**U.S. ROUTE 7 / AMES PLAZA / BROOK'S DRUG DRIVE
 (SEE SHEET 33 OF 67)**

VEHICLE DETECTOR LOOP LAYOUT DETAIL #1

PROJECT NAME: SALISBURY - MIDDLEBURY
 PROJECT NUMBER: NH_2311(1)S
 FILE NAME: ZpqveZQibQ18ZpbQ18.dgn PLOT DATE: 10-JUL-2006 13:30
 PROJECT LEADER: LEW DRAWN BY: LEW
 DESIGNED BY: LEW CHECKED BY:
 IPARM FILE NAME: pbQ18dt1.i SHEET 60 OF 67

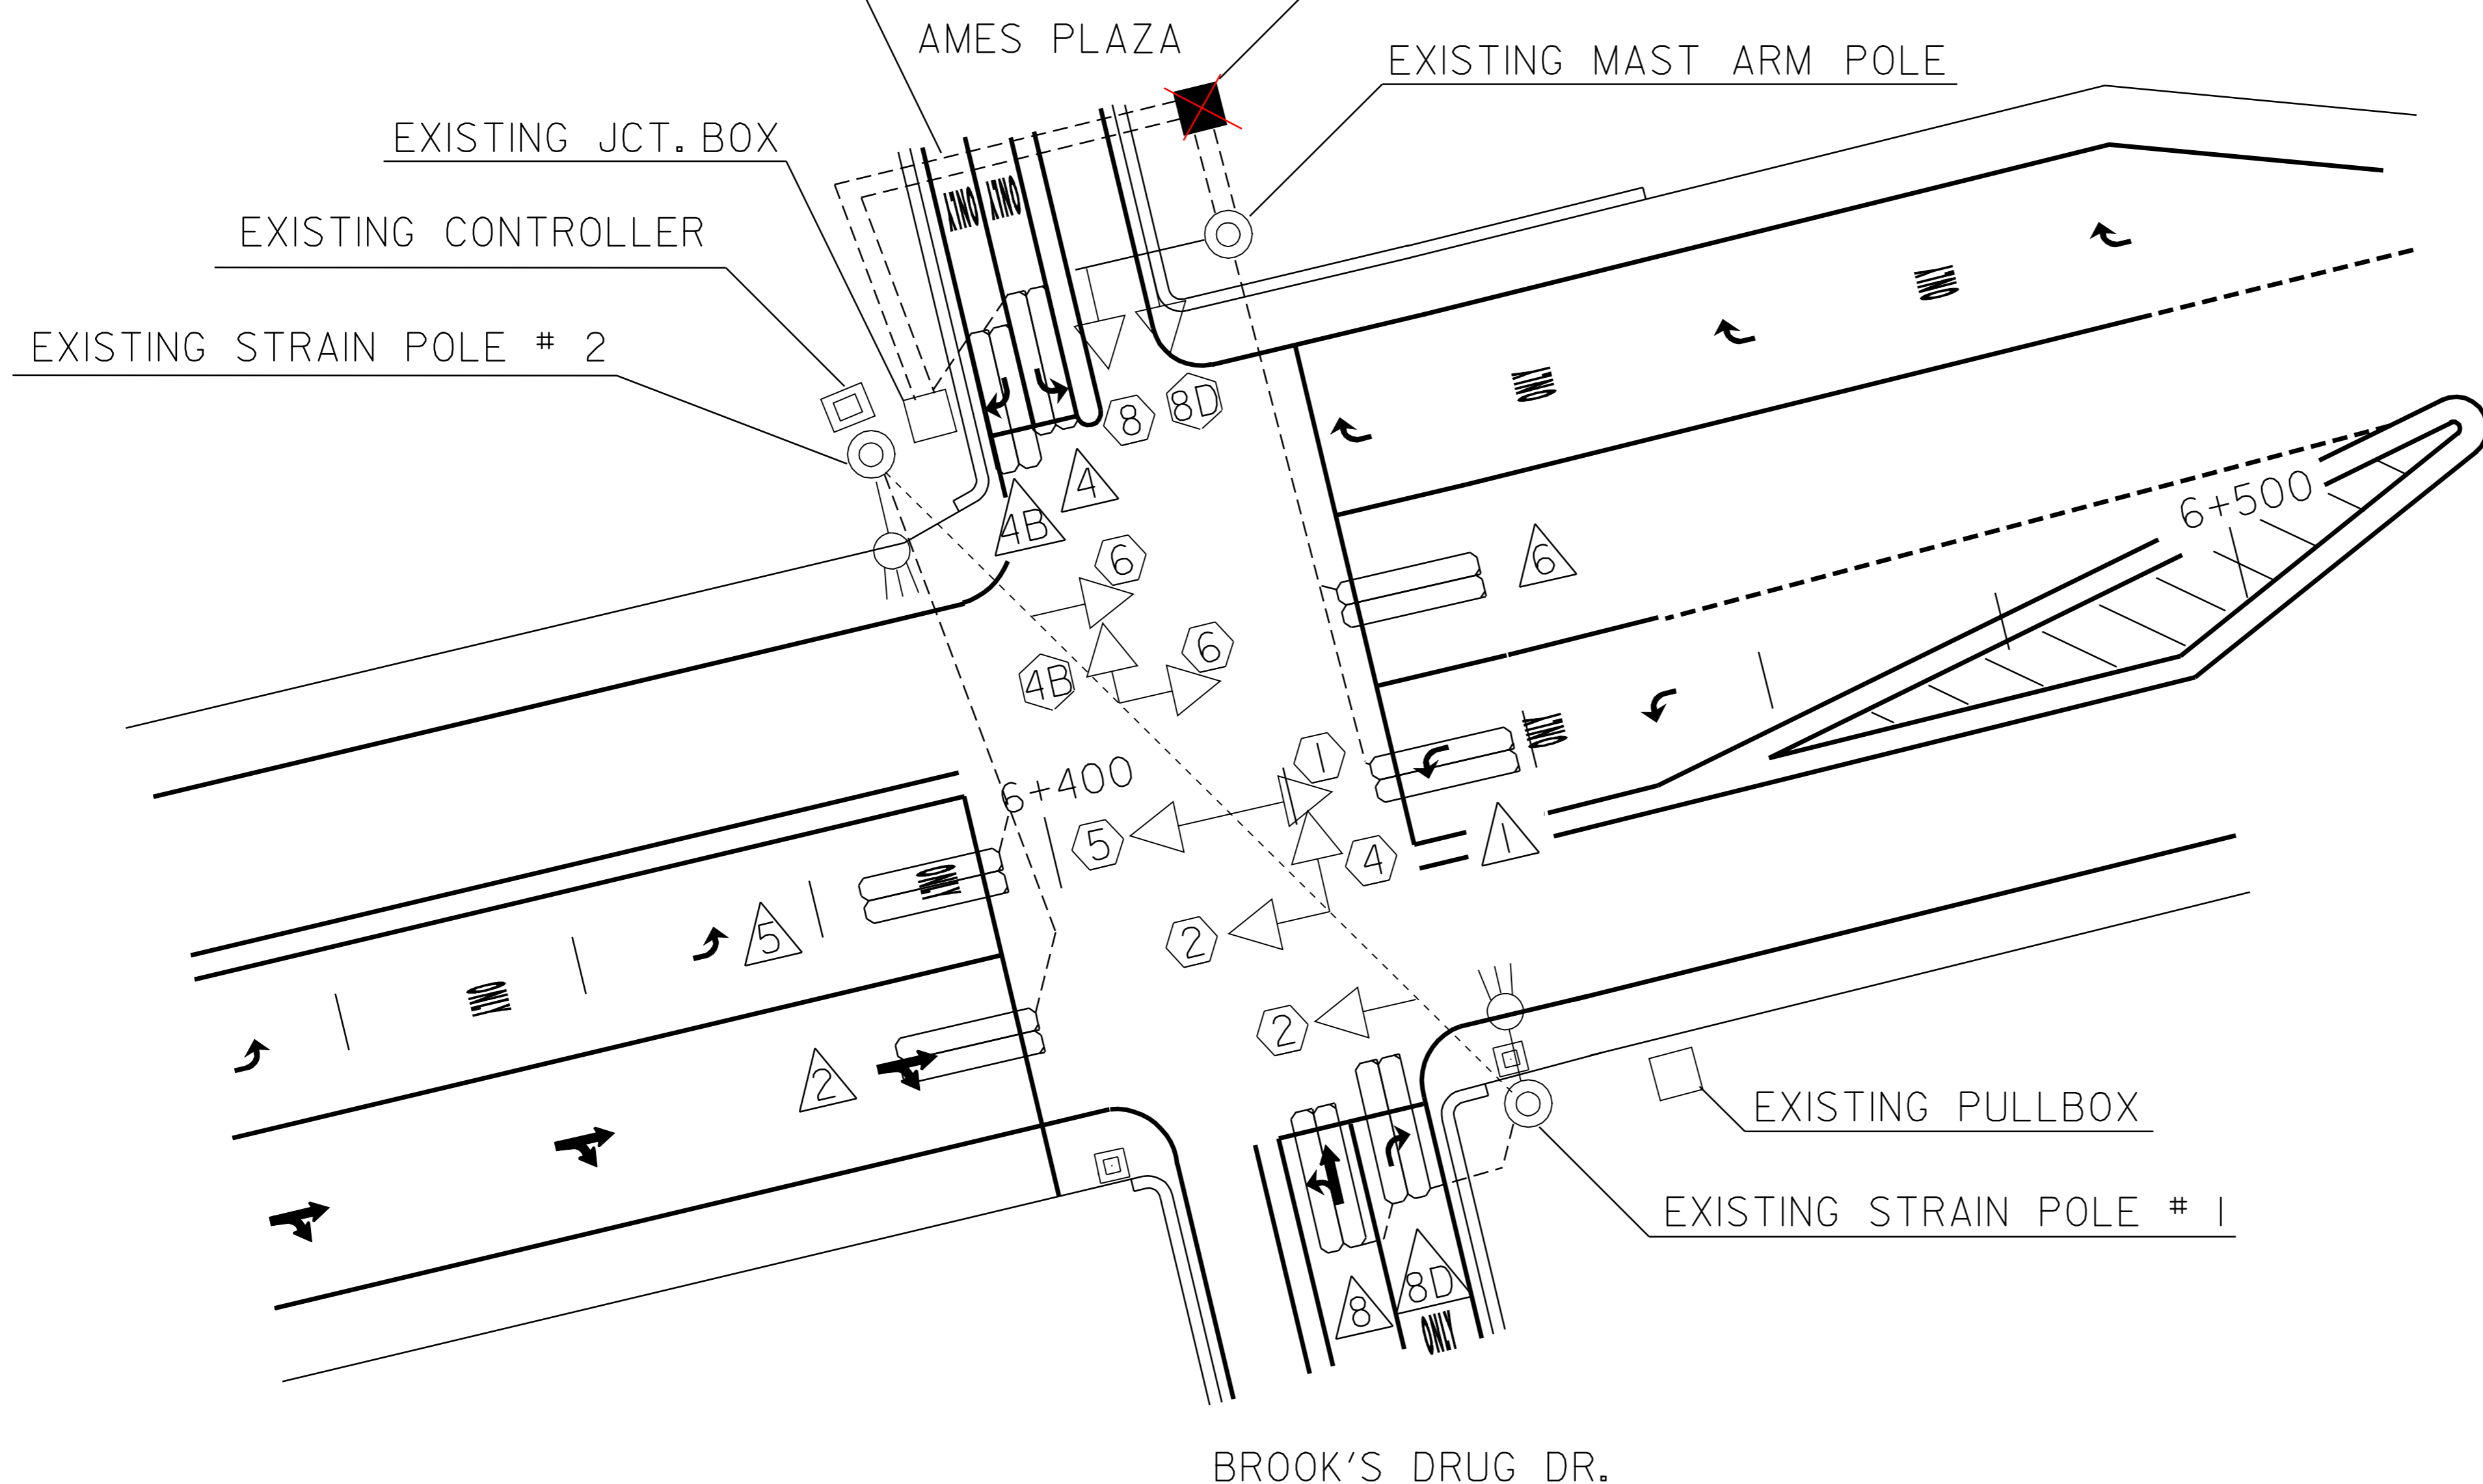
~~NOT REPLACED~~ ~~REPLACE PULLBOX W/ JCT. BOX JB S-1~~
 EXTEND EXISTING STEEL SLEEVE AND REWIRE AS NECESSARY.
